GREENWOOD TOWNHOMES

10512 GREENWOOD AVENUE NORTH

ADMINISTRATIVE DESIGN REVIEW RECOMMENDATION

0#.#.#.19 | MUP # 3030207-LU

3RD FLOOR BEDROOM LOOKING AT ADJACENT UNITS

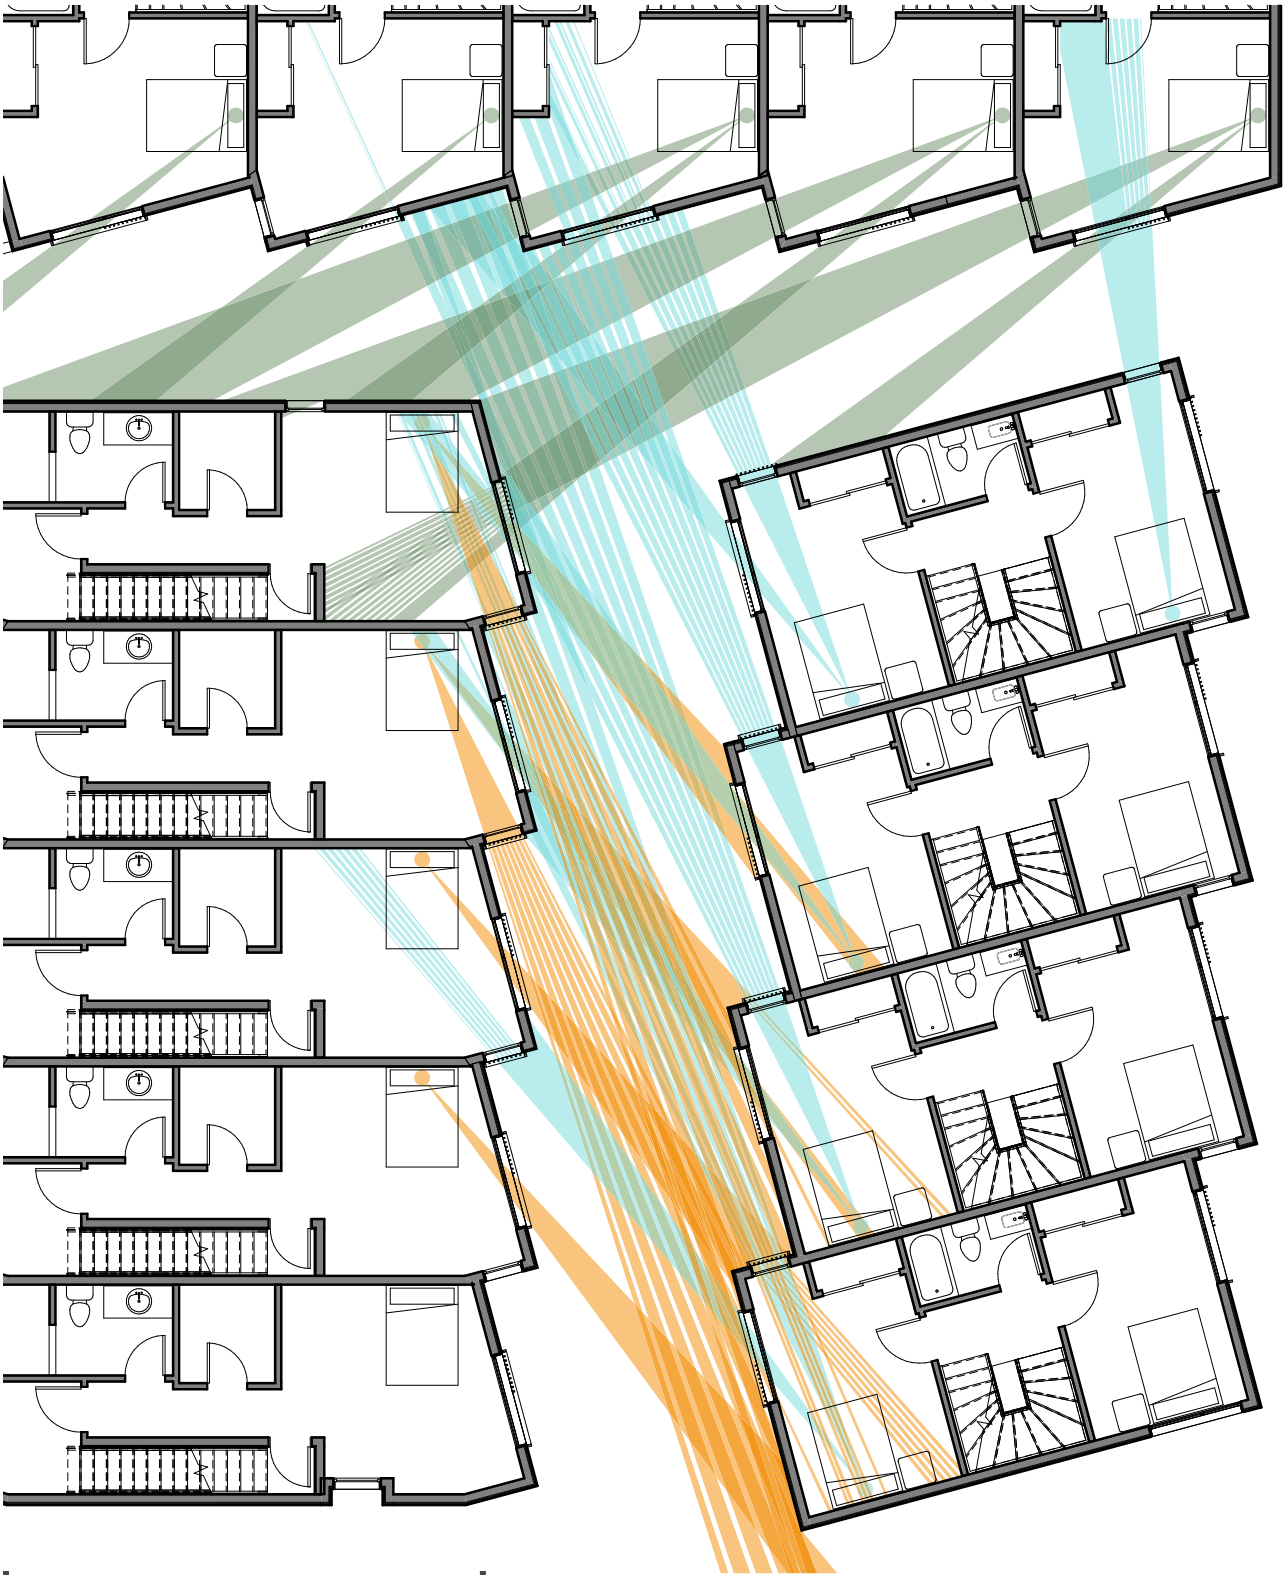
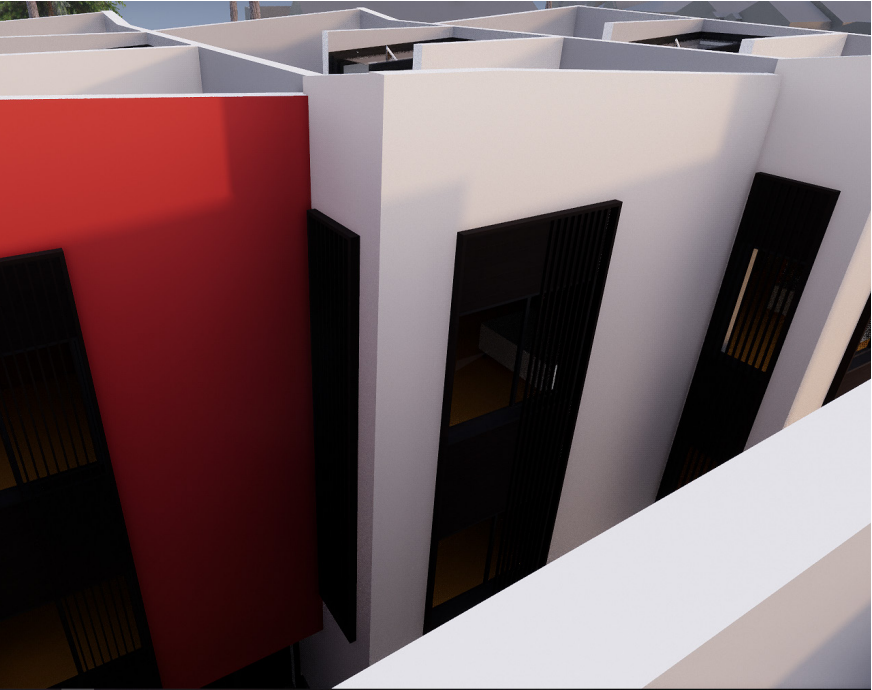
B) The Board was concerned about privacy impacts caused by window locations on other facades as well as the location of roof decks. Careful consideration of where to locate these features is required. Provide privacy studies in the recommendation packet. (CS2-D-5)

A window study was done to justify the position of the windows and the screening. Any view into a private area of an adjacent unit was successfully broken up by the sawtooth angle or the screen element.

DEPARTURE #1
JUSTIFICATION

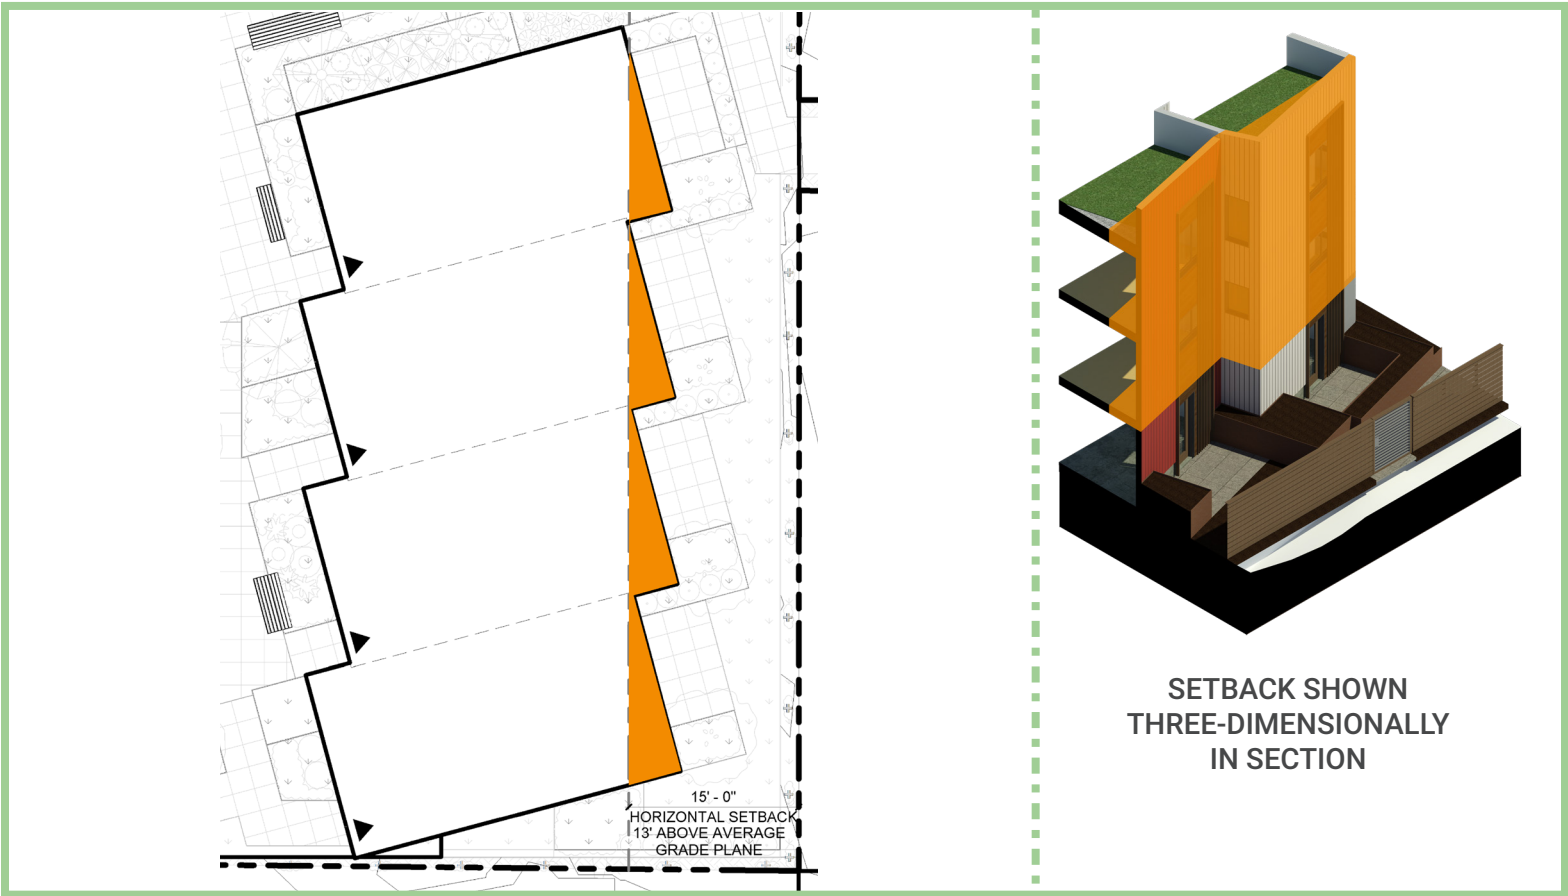
REQUESTED DEPARTURE
Request that portions of the structure be allowed to encroach into the setback.

RATIONALE
The “Code Compliant Design” explored the possibility that a departure is not granted and how to maximize those units without intersecting the setback. The mass was shifted West slightly, shrinking the center open space, to maintain interior clearances of the unit. The first floor is pulled out to 3 feet from the property line creating an appealing deck space for the occupants. However, this option does not appeal to the neighbor’s concerns of privacy nor the large flat mass facing the rear lot.

With a granted departure the massing breaks up and becomes a more dynamic form that faces the rear yard (CS2-D-4). This in conjunction with removing the fourth story responds to the neighbor’s concerns (CS2-D-3/5) and reflects similar decisions as seen through-out the project. This solution embraces privacy while providing more angled windows than the “Code Compliant Design,” as well as increasing the internal privacy between the East and West unit clusters (DC3).

In comparison, less square footage is built within 15’ of the rear property line in the “Preferred Design” (138.12 SF under 13’ above grade plane, and 276.24 SF above 13’ above grade plane, totaling 414.36 SF), than there is with the “Code Compliant Design” (767.80 SF under 13’ above grade plane).

DEPARTURE #2

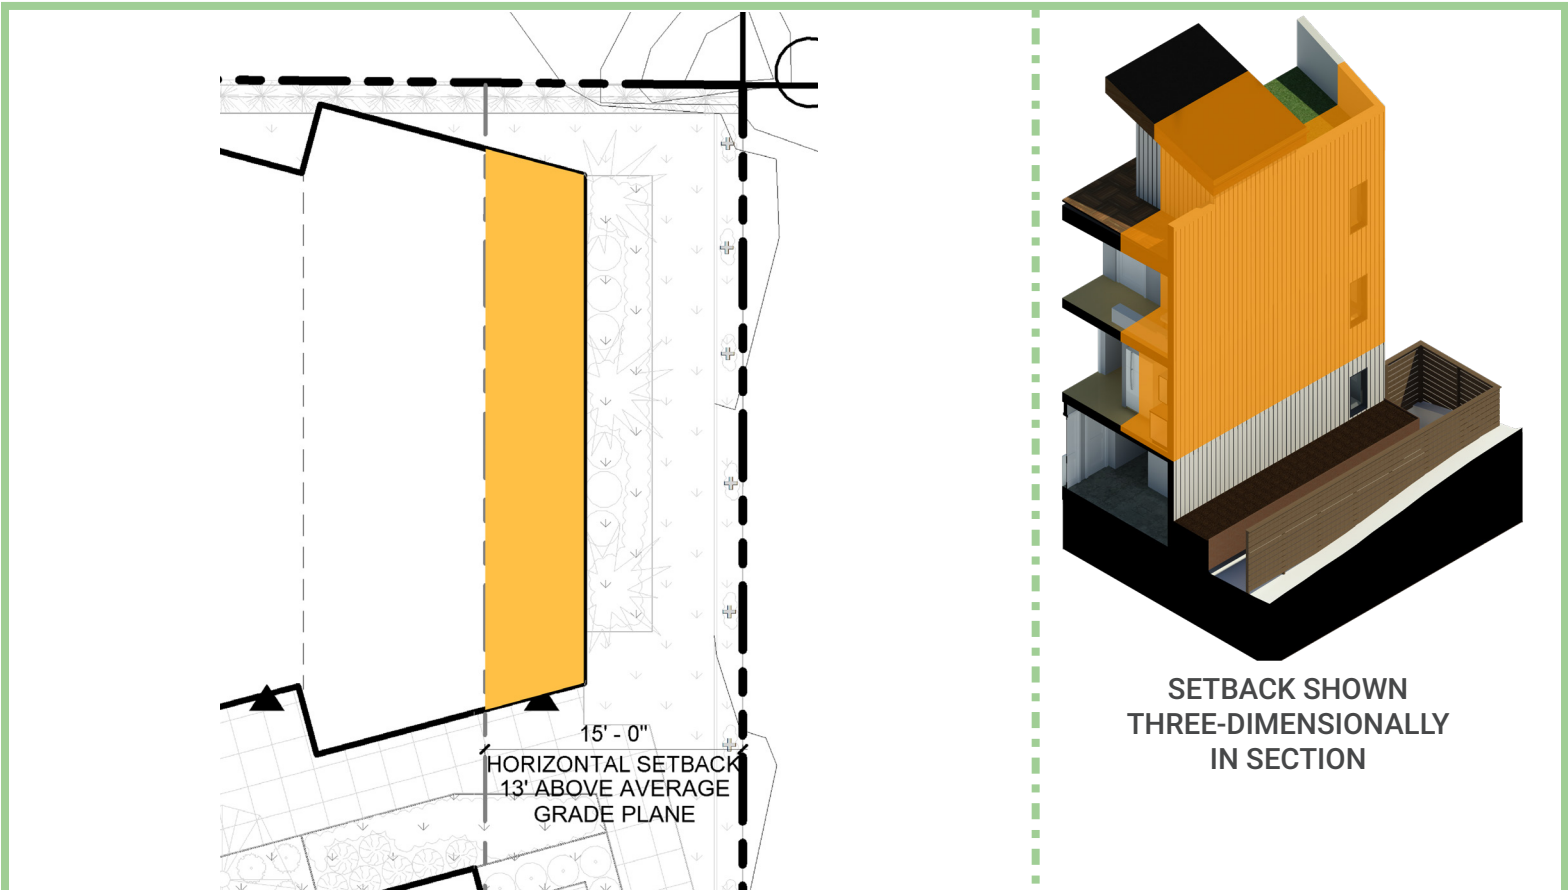
Request that the required 15 foot setback above 13 feet to a maximum of 40’ on against the single-family zone on the East property line be vacated.

The “Code Compliant Design” explored the possibility that a departure is not granted and how to maximize the unit without intersecting the setback. Units to the East side of the North cluster were reduced in width and height to keep the mass outside of the setback. This design keeps the stepped massing, but pushes the 4 story mass to the East property line (the 3 story skinny units do not have the internal clearance to reach 4 stories). The first floor is pulled out to 3 feet from the property line creating an appealing deck space for the occupants. However, this option does not appeal to the neighbor’s concerns of privacy nor the large flat mass facing the rear lot along their property line.

With a granted departure, the North cluster of units can maintain the rhythm of it’s dynamic facade (CS2-D-4). This in conjunction with removing the fourth story of the Eastern unit (DC2-A-2), adding landscape buffering along the facade, and using minimal windows, responds to the neighbor’s concerns about building too close to existing trees, large flat facades, and privacy (CS2-D-3/5). This solution embraces privacy while stepping down in mass to respect the adjacent sites to the rear (CS2-D).
